ACCESSION NBR: 8709100204 DOC. DATE: 87/09/01 NOTARIZED: NO DOCKET #
 FACIL: 50-244 Robert Emmet Ginna Nuclear Plant, Unit 1, Rochester G 05000244
 AUTH. NAME AUTHOR AFFILIATION
 ROBER, R. W. Rochester Gas & Electric Corp.
 RECIP. NAME RECIPIENT AFFILIATION
 RUSSELL, W. T. Region 1, Office of Director

SUBJECT: Responds to NRC 870730 ltr re deviations noted in Insp Rept
 50-244/87-11. Corrective actions: pipe supports redesigned to
 use new Hilti Kwik-Bolts in place of existing shell-type
 anchor bolts. Revised support drawings encl.

Subject: Inspection No. 50-244/87-11
R.E. Ginna Nuclear Power Plant
Docket No. 50-244

RESPONSE TO NRC INSPECTION NO. 50-244/87-11

PIPE SUPPORT MK-CCU-86	S-382-356	086 C	3
TITLE	DRAWING NUMBER	SHEET	REV.

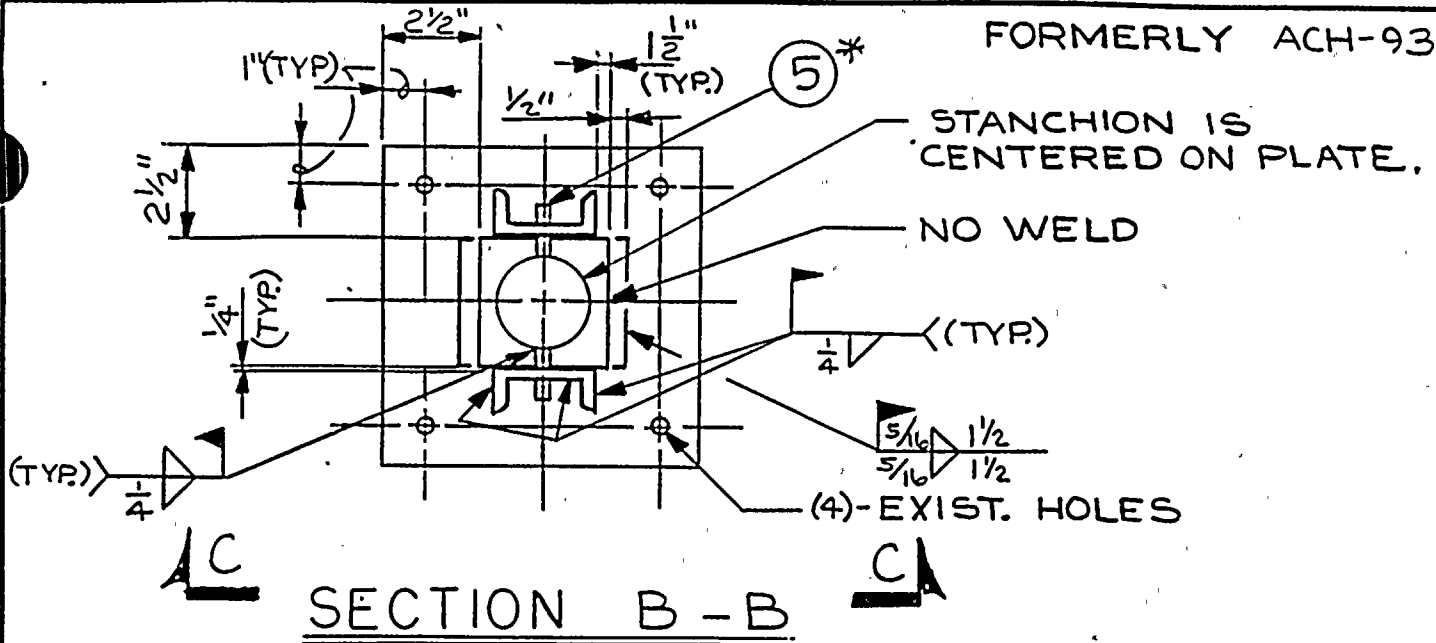
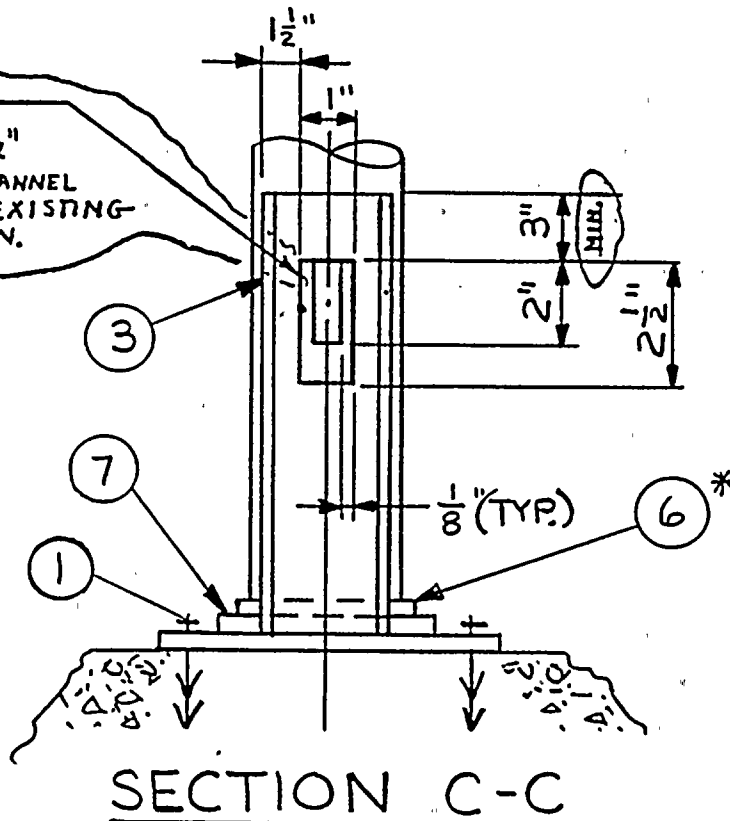
DISPOSITION: REMOVE EXISTING BASE PLATE, ANCHOR BOLTS, CHANNELS, AND GROUT STRUCTURALLY GROUT EXISTING HOLES IN ACCORDANCE WITH ME 121. INSTALL NEW BASE PLATE, HILTI'S, CHANNEL SECTIONS AND SHIM PLATE.

PIPE SUPPORT MK-CCU-156	S-382-356	156 B	3
TITLE	DRAWING NUMBER	SHEET	REV.

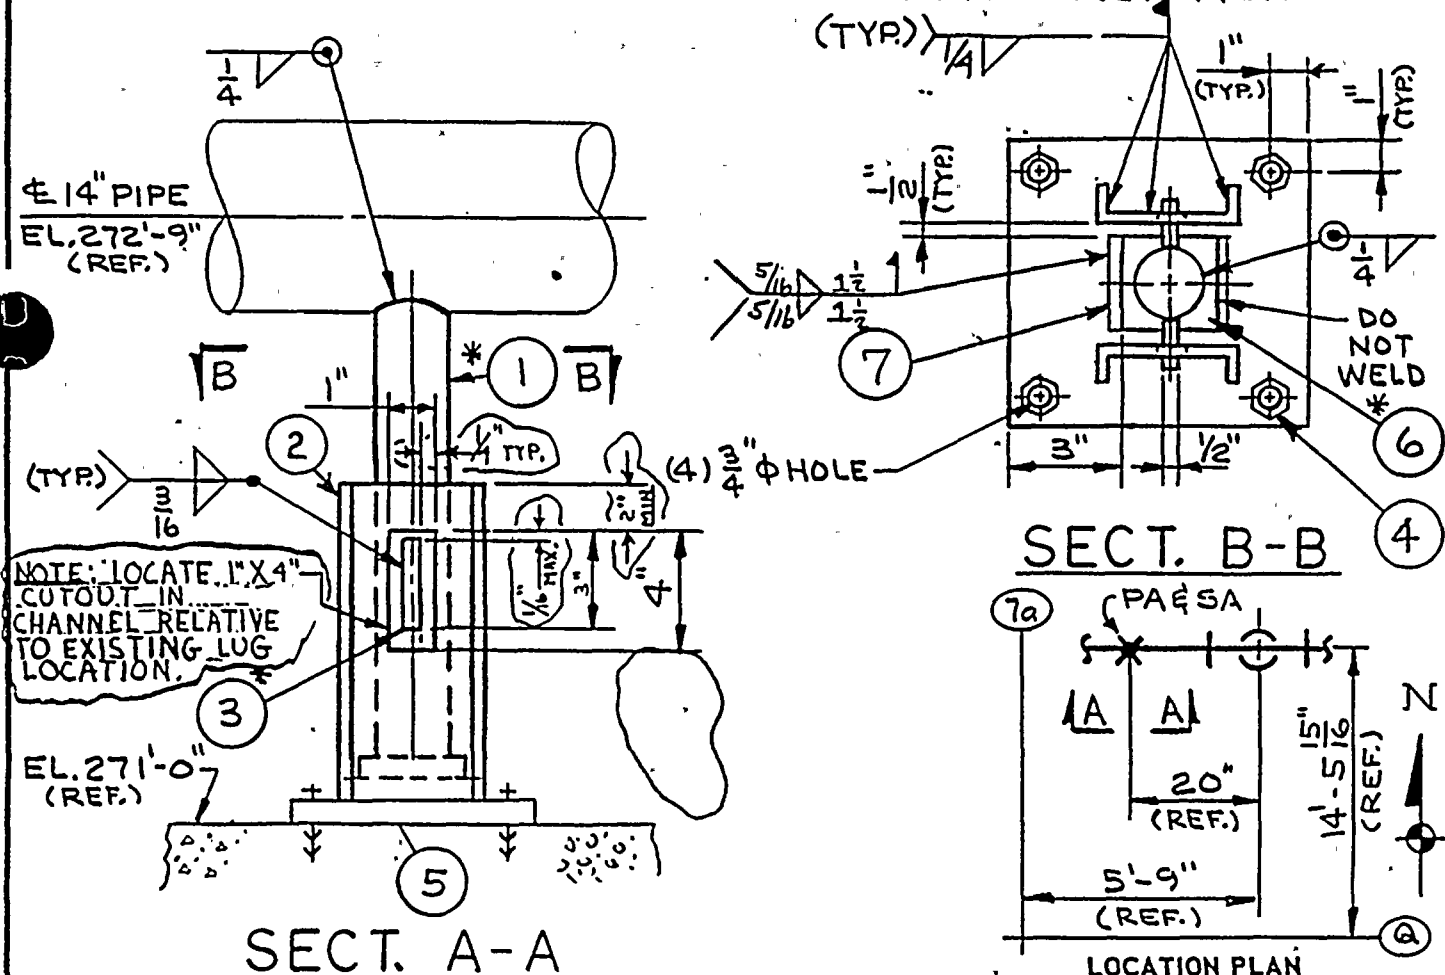
DISPOSITION REMOVE EXISTING BASE PLATE, ANCHOR BOLTS, CHANNELS, AND GROUT. STRUCTURALLY GROUT EXISTING HOLES IN ACCORDANCE WITH ME121. INSTALL NEW BASE PLATE, HILTI'S CHANNEL SECTIONS AND SHIM PLATE. NUCLEAR SAFETY RELATED

PIPE SUPPORT MK-SWU-196	S-382-358	196 B	4
TITLE	DRAWING NUMBER	SHEET	REV.

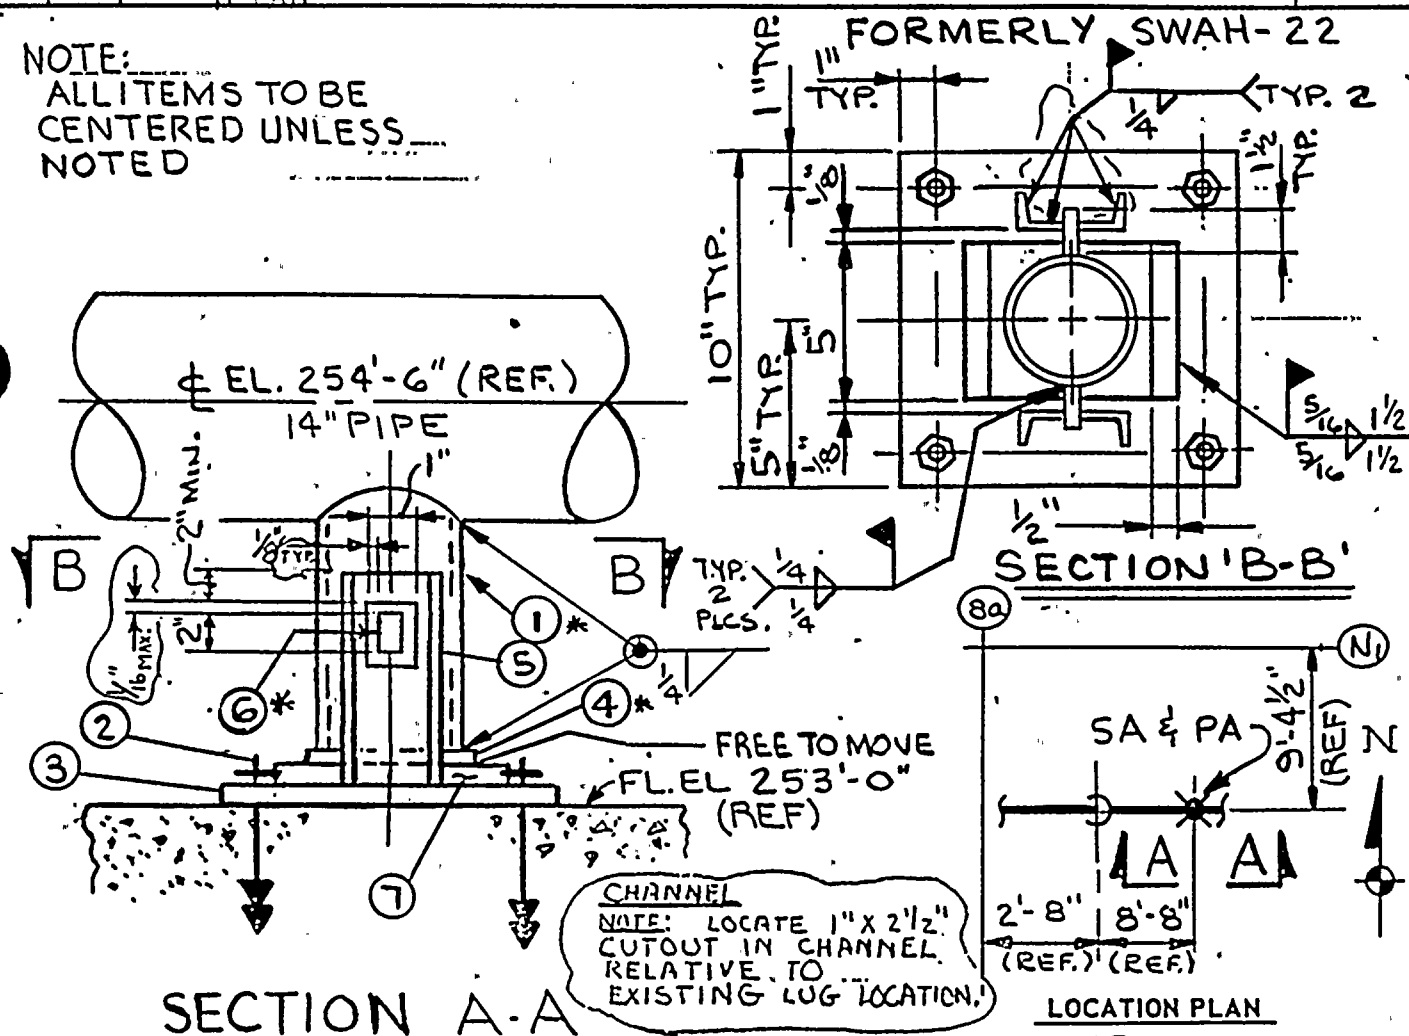
DISPOSITION: REMOVE EXISTING BASE PLATE, ANCHOR BOLTS, CHANNELS, & GROUT. FILL EXISTING HOLE WITH STRUCTURAL GROUT IN ACCORDANCE WITH ME-121. INSTALL NEW BASE PLATE, HILTI'S, CHANNEL SECTIONS, AND SHIM PLATE.

PIPE SUPPORT MK-SWU-198	S-382-358	198 C	4
TITLE	DRAWING NUMBER	SHEET	REV.

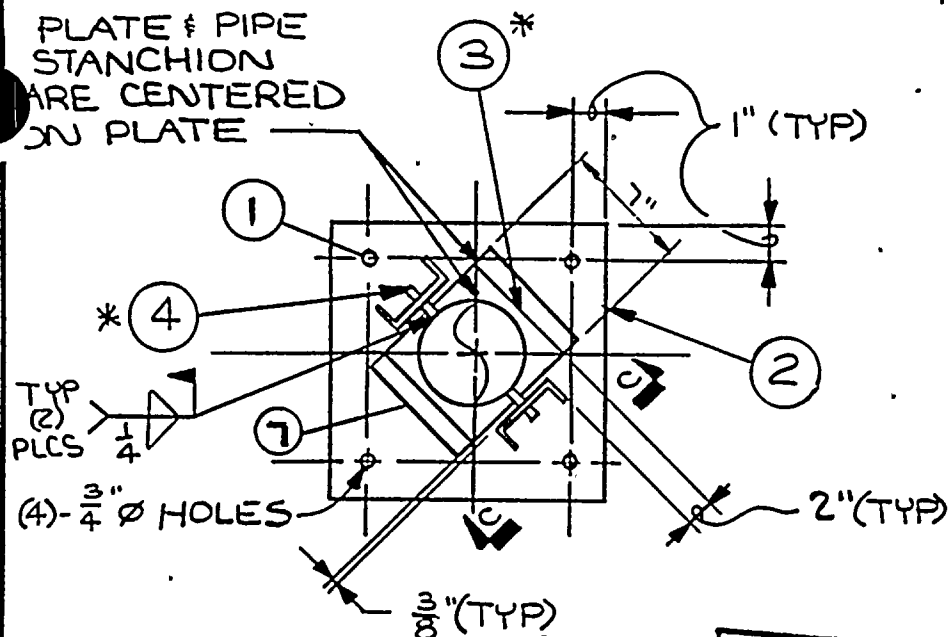
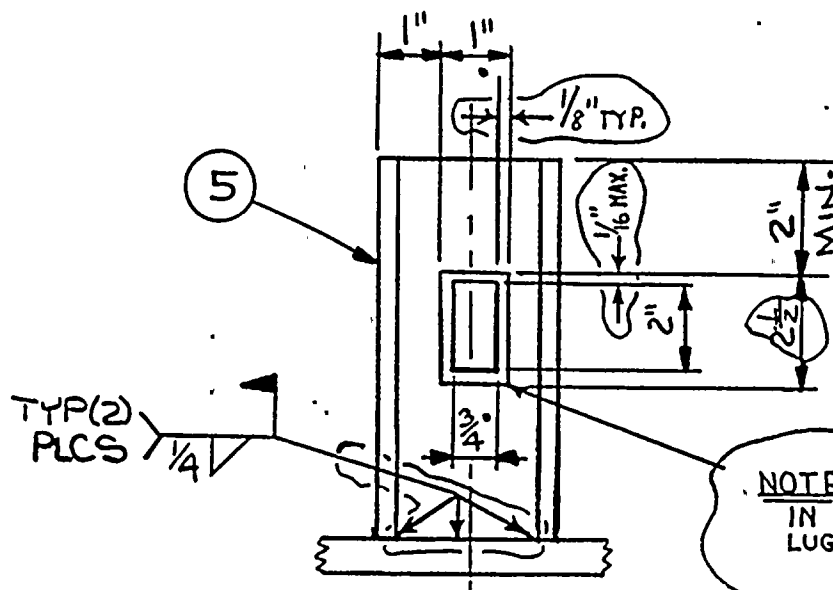
DISPOSITION: REMOVE EXISTING BASE PLATE, ANCHOR BOLTS, CHANNELS & GROUT
 FILL EXISTING HOLE WITH STRUCTURAL GROUT IN ACCORDANCE WITH
 ME-121. INSTALL NEW BASE PLATE, HILTIES, CHANNEL SECTIONS,
 AND SHIM PLATE.
